Re: In the Matter of PUBLIC UTILITY COMMISSION OF OREGON, General Capacity
Investigation
Docket No. UM 2011

**Value of Capacity
July 15 UM 2011 Workshop**

Redline comments of the Renewable Energy Coalition

Figure 1: Wind non-renewable annual QF avoided cost payments at hypothetical 37.2% capacity factor

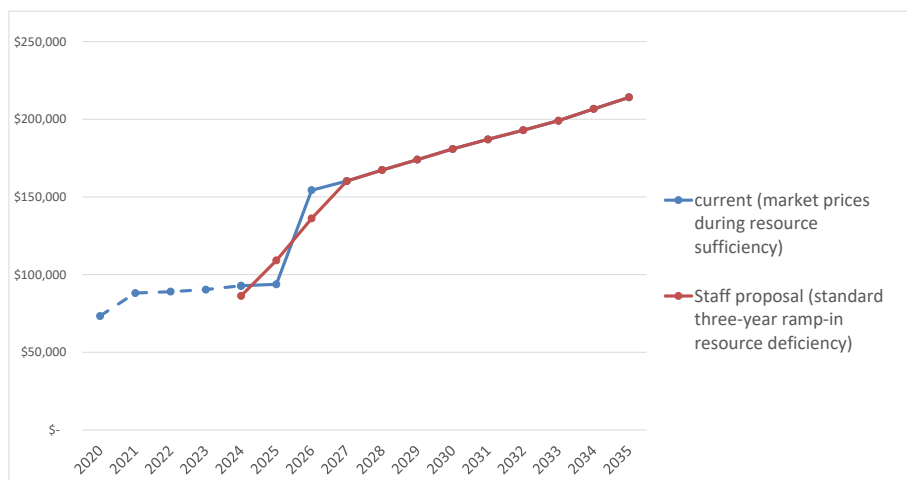
Commented [A6]: The Renewable Energy Coalition understands this Appendix to provide an illustrative capacity value example based on Staff's straw proposal. The Coalition is not revising the example, but it maintains all of its suggestions above.
